# City of Alexandria, Virginia

## **MEMORANDUM**

SUBJECT: REVISION TO DOCKET ITEM #13 – MPA #2019-00008 – 3601 Potomac

# RESOLUTION NO. MPA 2019-00008

Figure 3.1: Framework Streets and Figure 6.2: Proposed Street Network

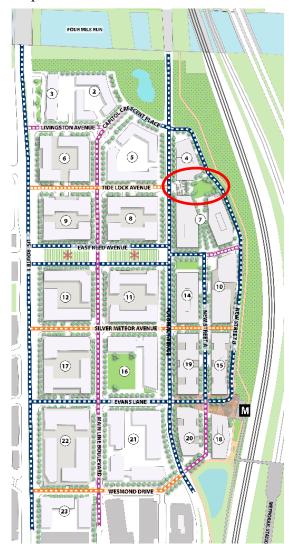
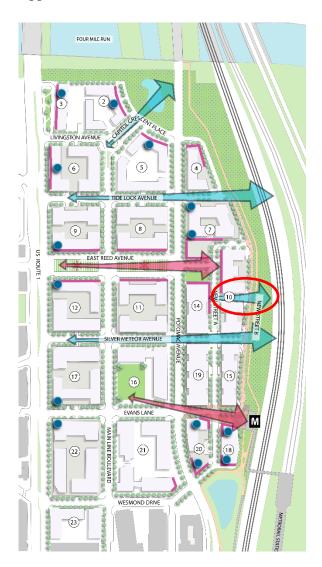
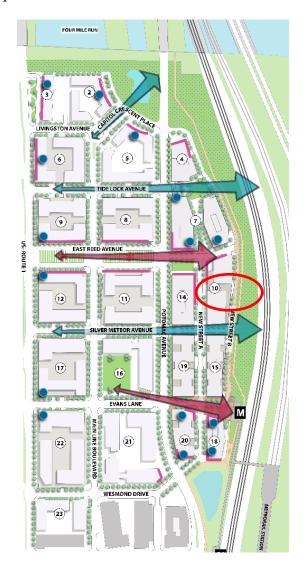
- Figure 3.1: Framework Streets
- Figure 3.2: Street Hierarchy
- Figure 3.4: Gateways & Vistas
- Figure 4.1: Land Use Plan and ¼ Mile Pedestrian Walkshed (1/2 Mile pedestrian walkshed covers North Potomac Yard area)

<u>Figure 4.1</u>: Land Use Plan and ¼ Mile Pedestrian Walkshed (1/2 Mile pedestrian walkshed covers North Potomac Yard area) and <u>Figure 9.1</u>: Land Use Plan, Required and Optional Retail Locations, and ¼ Mile Pedestrian Walkshed

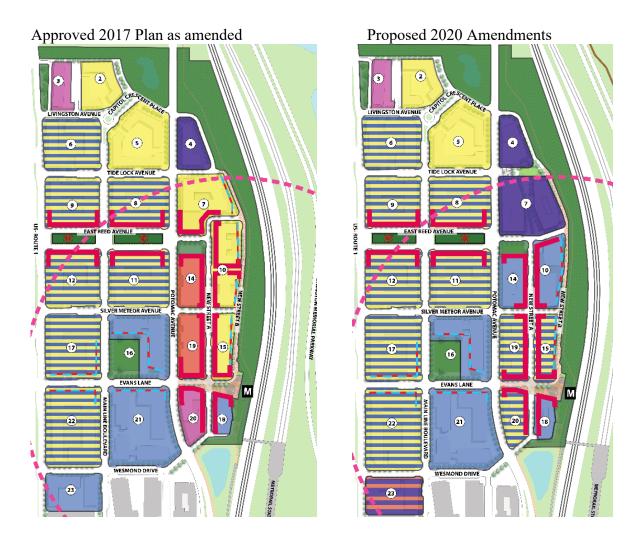
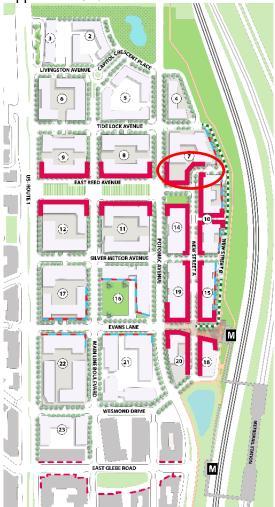
- Figure 5.1: Block 4 (23) School Reservation Site\_
- Figure 6.2: Proposed Street Network
- Figure 6.7: Bicycle Network
- <u>Figure 9.1:</u> Land Use Plan, Required and Optional Retail Locations, and ½ Mile Pedestrian Walkshed

Figure 4.3: Required, Optional, and Planned Retail Locations

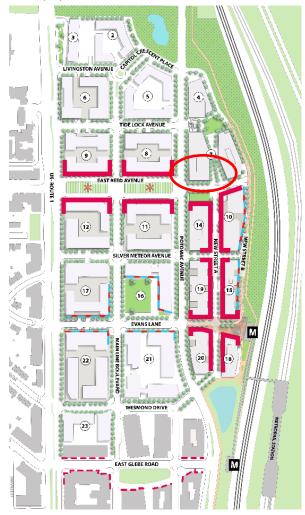
- Figure 4.3: Required, Optional, and Planned Retail Locations
- Figure 4.5B: Maximum Building Heights
- Figure 4.8: Plan Area Public and Private Parks with Public Access Easement
